Appendix E Flood Risk Clarifications – Envirocentre, December 2018.

Riverside West: Flood Risk Clarifications - Briefing Note 01

Riverside West: Flood Risk Clarifications – Briefing Note 02

Subject: 168659: West Riverside - Area C

Figure 1: Example long section through Pier Head area (alignment shown in Drawing 168569-061)

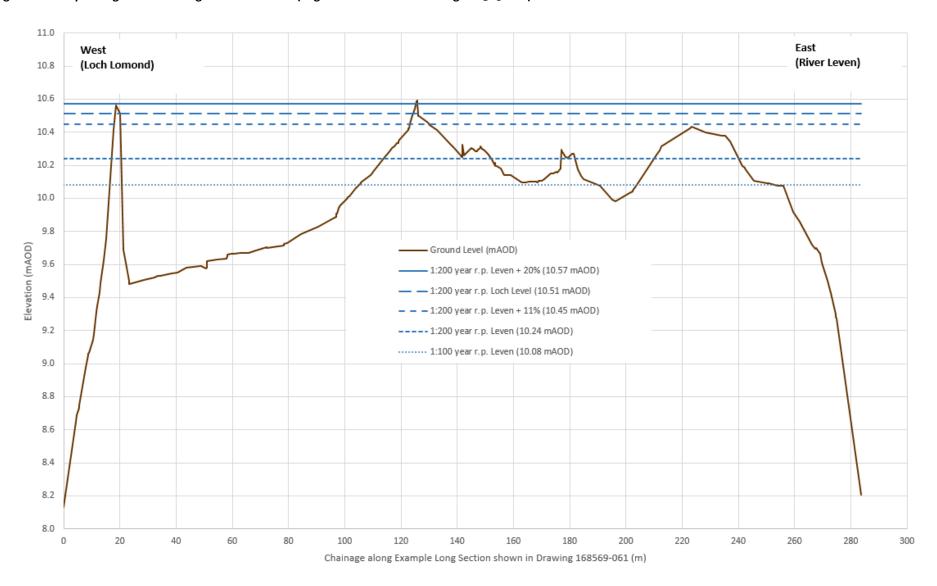
existing car parking lies within the flood risk zone of the River Leven. The Water Park lies within the flood risk zone of Loch Lomond and is considered a water compatible development, while a small proportion of the Hotel is shown to also encroach into the Loch Lomond flood risk zone. The Visitor Hub remains outwith the flood risk zones. A long section showing the ground levels through the elements presently shown in the Loch Lomond flood zone is shown in Drawing 169659_061 and is plotted in Figure 1 along with modelled water levels which is appended to this note.

Figure 1: The two photographs of the 3 culverts viewed from downstream of Old Luss Road

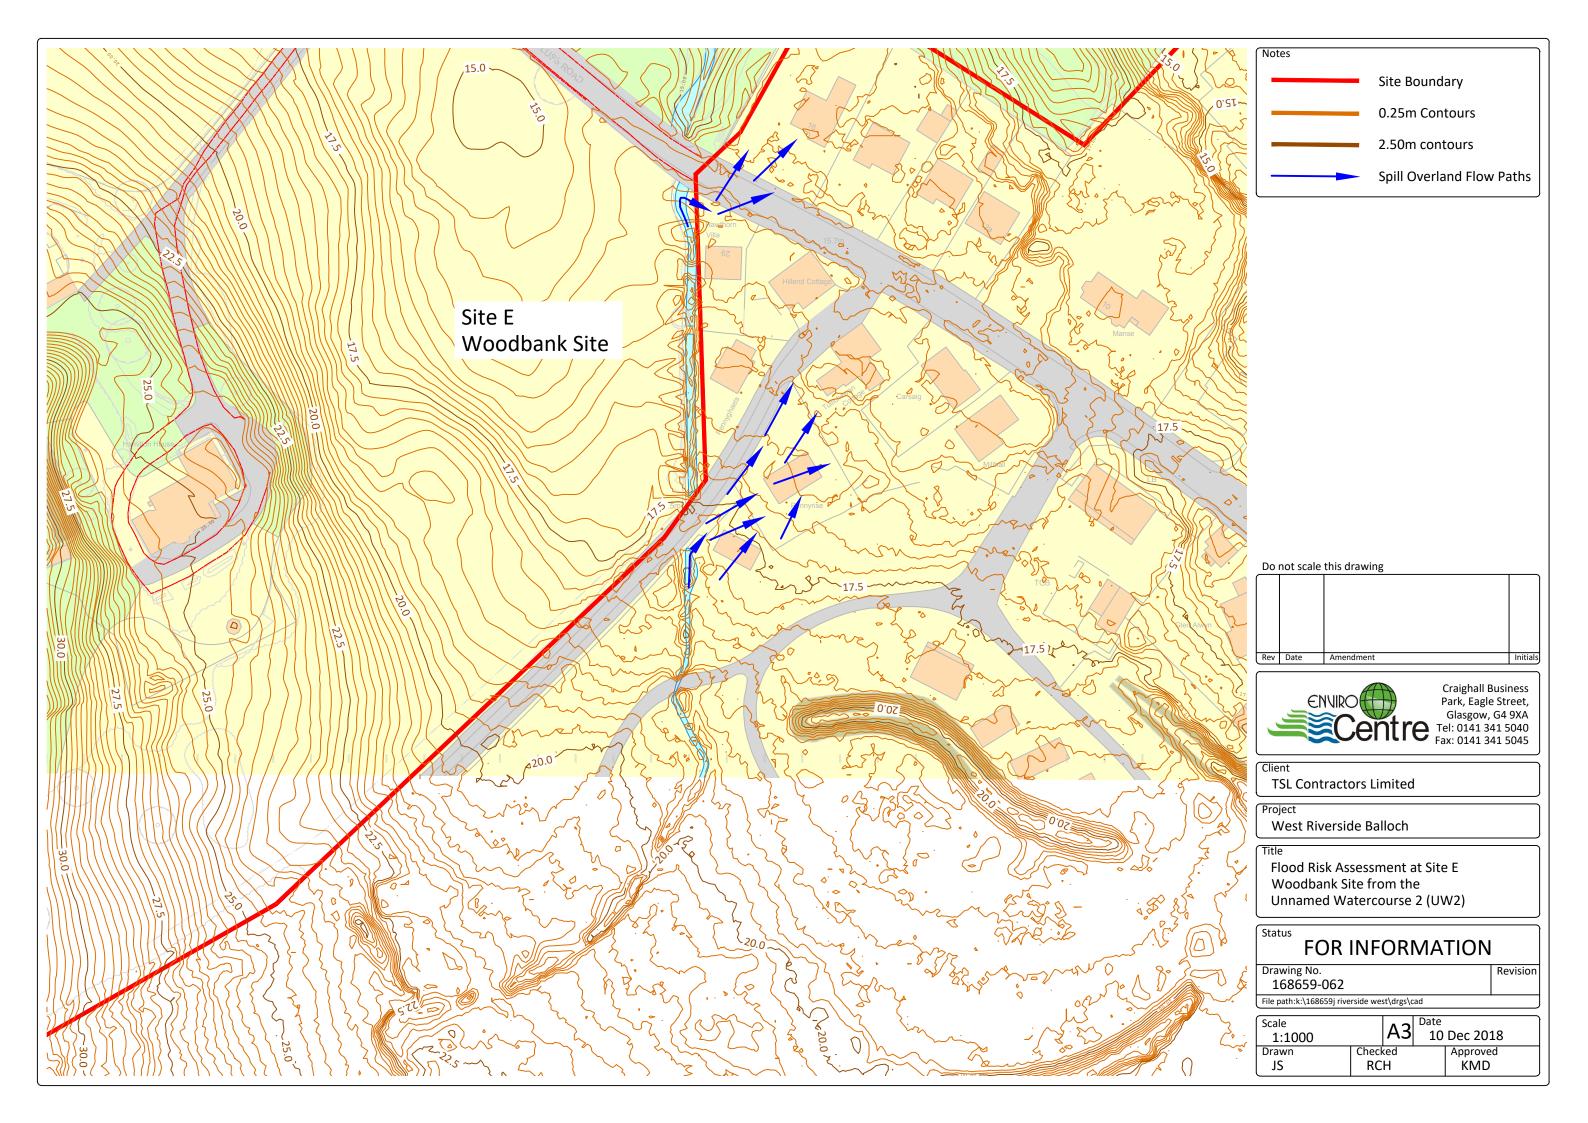
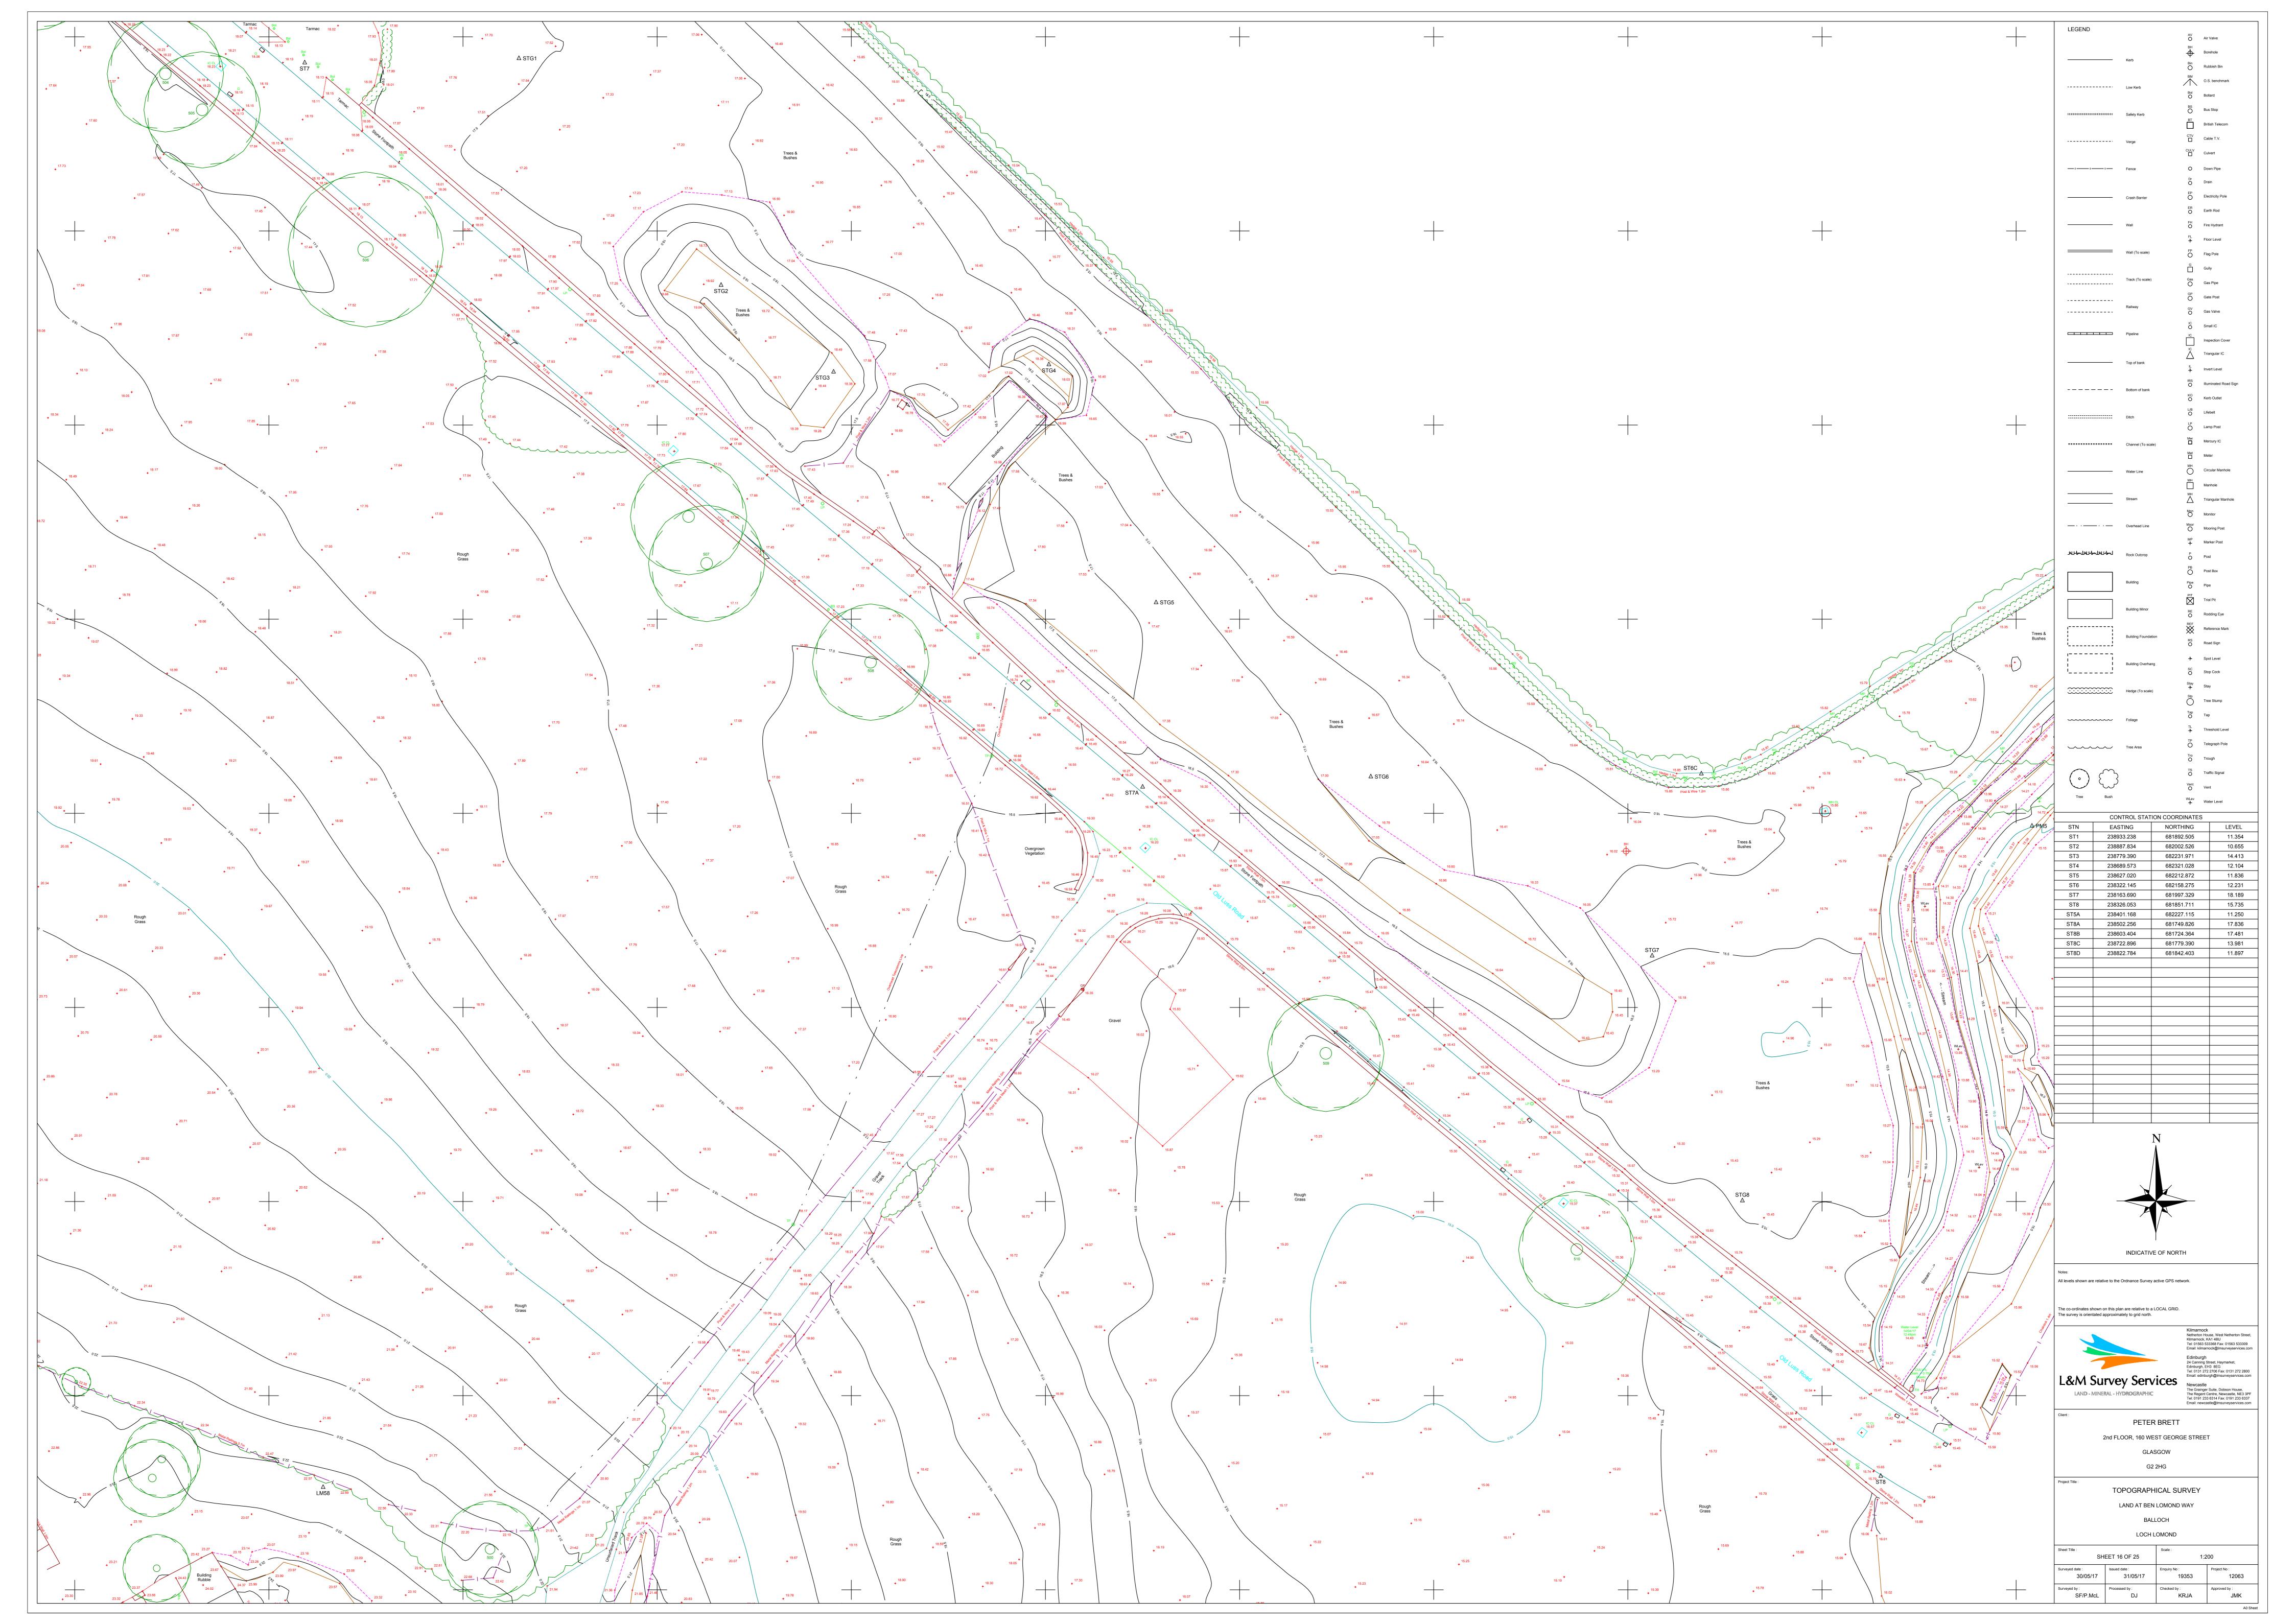
- 7. Whilst during the site walkover the inlet(s) to the culvert(s) under Old Luss Road were submerged, we have since obtained more information, through the photos taken by a resident and provided to SEPA. One of the photographs that have been made available to SEPA is reproduced as Figure 1.

- 8. It is evident from the photographs that there are 3 No. culverts with estimated diameters of at 0.6 m.

- 9. Based on this information, all flow emerging on the downstream side of the 2 No. similarly sized (0.5 0.6 m dia.) culverts under Lower Stoneymollan Road would be conveyed by the 3 culverts under Old Luss Road as their hydraulic conveyance capacity is larger, as long as the capacity is maintained. Any flooding due culvert capacity exceedance will first occur at the inlet to culverts under Lower Stoneymollan Road with the floodwater being conveyed overland in the north-easterly direction, away from the development site. To appreciate the topography in the surrounding area of UW2 in the vicinity of Woodbank Site, a topographic contour map developed from a 2017 topographic survey of the site supplemented by LiDAR ground model data outwith the site boundary is enclosed as Drawing 168659-062.

- 10. However, as the photos show the culverts under Old Luss Road are presently partially blocked due to sediment build up and therefore their conveyance capacity is significantly reduced. This clearly is a maintenance issue. Assuming the scenario of restricted capacity within the culverts persisted, it is anticipated that flood flows would accumulate around the inlet and potentially spill onto both the Woodbank site and also onto the existing residential gardens to the east. The available topographic survey for Woodbank Site (Sheet 16 of 25 enclosed), includes only a small part of the left bank (of UW2 around the Old Luss Road culvert inlet. A review of this topographic survey shows that ground levels on the rise up to 16.00 mAOD close to the inlet. Thereafter, as one moves away from the UW2 in the north-westerly direction, close to Old Luss Road, onto the site the levels drop forming a small depression-like feature.

Pierhead Hotel Footprint within Flood Development Zone

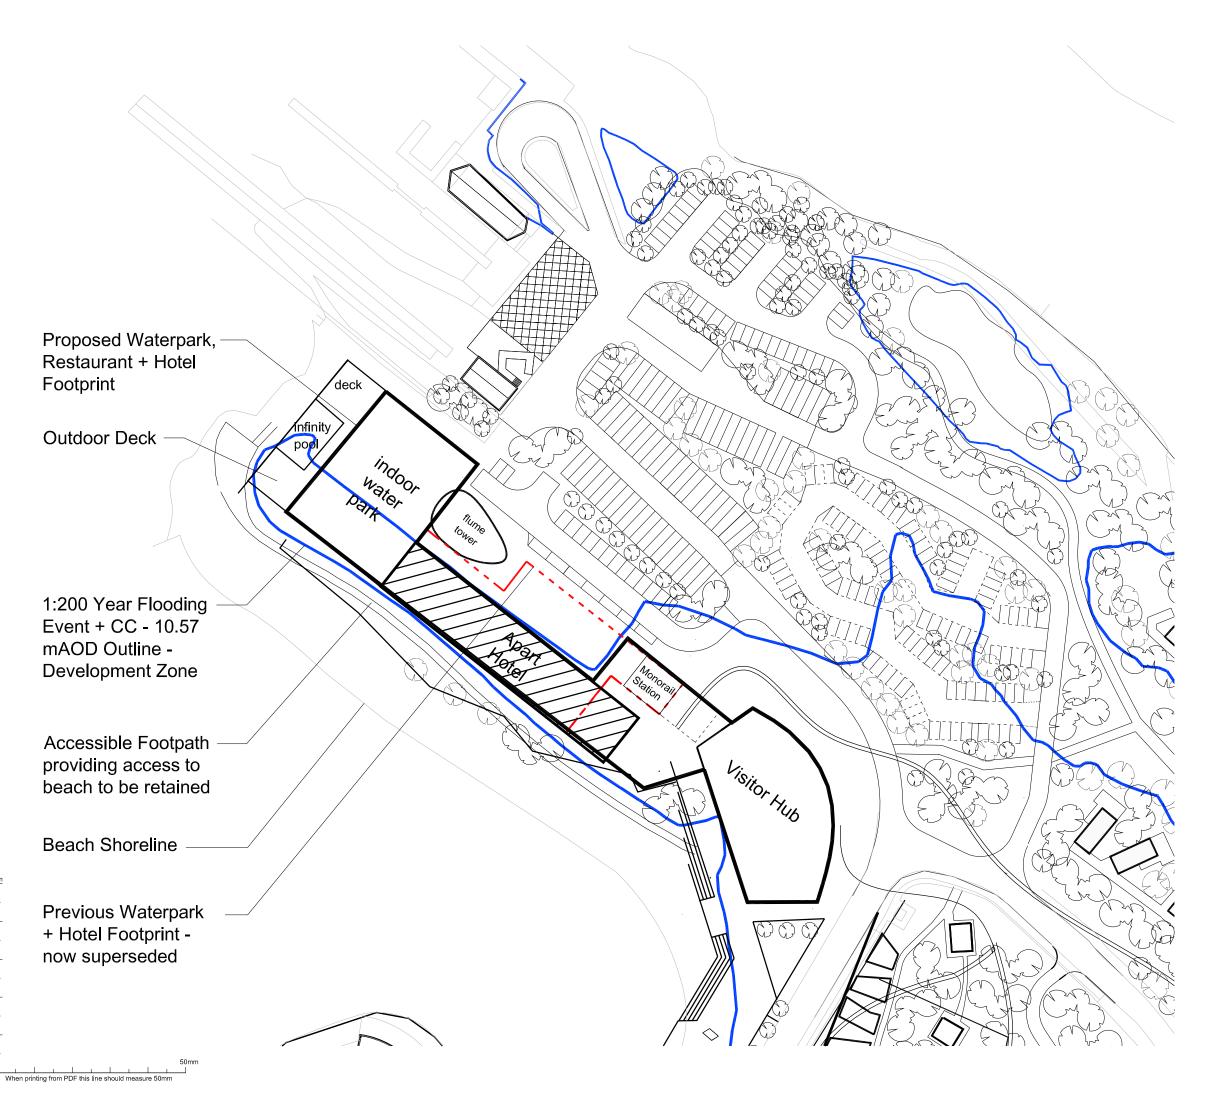
Following on from our earlier phone call, attached is the proposed revised layout that brings the hotel development out of the flood risk zone.

From our understanding at the meeting last week, the Water Park is considered 'Least Vulnerable' consistent with 'assembly and leisure' use and a re-development of similar existing use, so would be appropriate in the location shown.

We assume that with a footprint of 850 m² in the flood risk zone (existing ground levels range between 9.5 - 10.2 mAOD, design flood 10.57 mAOD), the Water Park would require appropriate compensatory storage as part of the detailed design stage?

The Flume Tower is an open structure and the Deck and Infinity Pool are shown at a level of 15 mAOD on the masterplan, expected to project out above the existing ground.

Prior to agreeing this revised layout, we would seek your confirmation that the above is acceptable to SEPA.

- 1.1 We would confirm that if we were to be formally consulted on the amended site layout, as shown on Drawing No 1139 SK020 we would be able to **remove our objection** to the proposed development on flood risk grounds. Notwithstanding this we would expect Loch Lomond & The Trossachs National Park to consult the relevant council to undertake their responsibilities as the Flood Risk Management Authority.
- 1.2 Our pre-application advice relies on the accuracy and completeness of the information supplied with this consultation. Should finalised development proposals differ in any future planning application we reserve the right to alter our position if we are of the opinion that such proposals would not meet with the principles of Scottish Planning Policy.

- 1.4 Review of planning drawing 1139 SK020 indicates that the proposed hotel development has been moved outwith the floodplain which was the main reason for our flood risk objection. We are satisfied with the revised location of the hotel with the caveat that some uncertainty remains with the flood hazard. We do however accept that this risk has partly been mitigated by using climate change levels to inform the functional floodplain.

- 1.5 It is also agreed that given the nature of the site that the water park is a least vulnerable use and provided any loss of floodplain is subject to appropriate compensatory storage the proposal should have an overall neutral effect on flooding. Therefore based on the revised proposal we are satisfied that it is compliant with the principles of Scottish Planning Policy (SPP).
